**City of Pembroke Pines**  
**Planning & Economic Development Department**  
**601 City Center Way 3<sup>rd</sup> Floor**  
**Pembroke Pines FL, 33025**

## Summary

<b>Agenda Date:</b>	June 26, 2025	<b>Application ID:</b>	SP2025-0004
<b>Project:</b>	Culver's	<b>Project Number:</b>	PRJ2024-0017
<b>Project Planner</b>	Cole Williams, Senior Planner		
<b>Owner:</b>	Raintree at Pines LLC	<b>Agent:</b>	Michelle Diaz-Mendez
<b>Location:</b>	1580 South Hiatus Road	<b>Commission District</b>	1
<b>Existing Zoning:</b>	C-1 (Commercial)	<b>Existing Land Use:</b>	Commercial (Flexibility Rule Applied)
<b>Reference Applications:</b>	ZV2025-0007, ZC 2024-0003, SP2021-08, SP2020-09, ZV 2020-08, SP 2017-03, ZV 2017-02, ZV 2017-03, ZV 2017-04, ZV 2017-14, ZC 2017-02, SP 2015-01, SP 2014-22, MSC 2010-07, SP 2008-02, MSC 2007-71, SP 2006-53, ZC 2005-06, ZC 2005-07, ZC 2003-02, AM 2003-07		
<b>Applicant Request:</b>	Construct a free-standing drive-thru restaurant (Culver's) with associated site, signage, circulation, parking and landscape improvements.		
<b>Staff Recommendation:</b>	<b>Approval</b>

"NO PARKING FIRE LANE"  
SIGN (18"x24")  
PER N.F.P.A. 18.2(3)(5)3

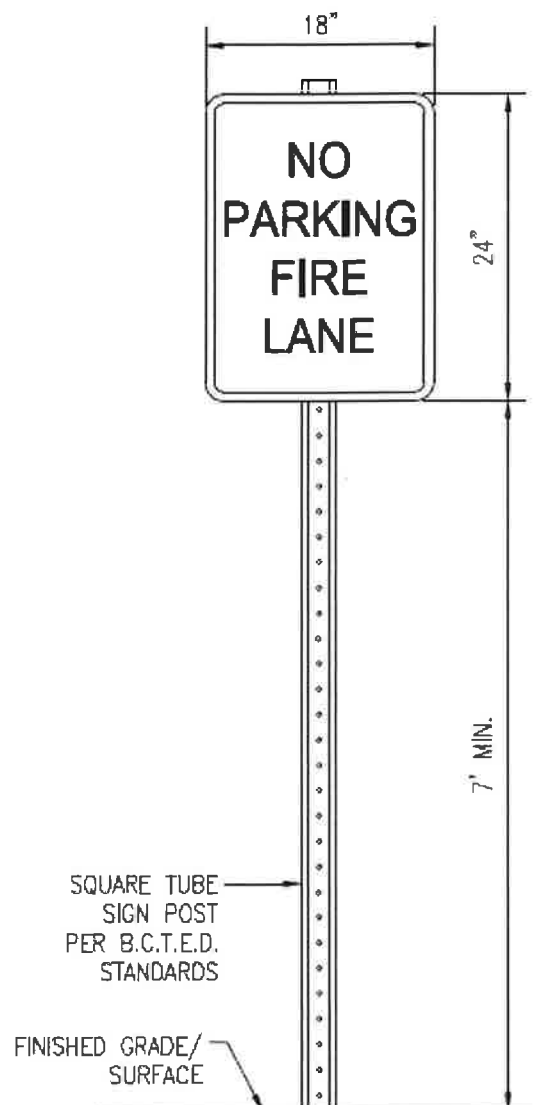
7. Fire Truck Access Plan, Sheet S-4 – Any required Fire Lane markings and signage as may be required by the criteria/requirements of the Fire Prevention Bureau must be reflected on the plan. In addition, the sign post for the ‘Fire Department Connection Sign’ is required to comply with the current support post per the Broward County Traffic Engineering Division (BCTED) standards/details.

SIGN SHALL HAVE WHITE BACKGROUND WITH RED LETTERS AND SHALL BE 7' IN HEIGHT TO BOTTOM OF SIGN. ALL SIGNS SHALL FACE THE FLOW OF TRAFFIC AND BE A MAXIMUM OF 60' APART.
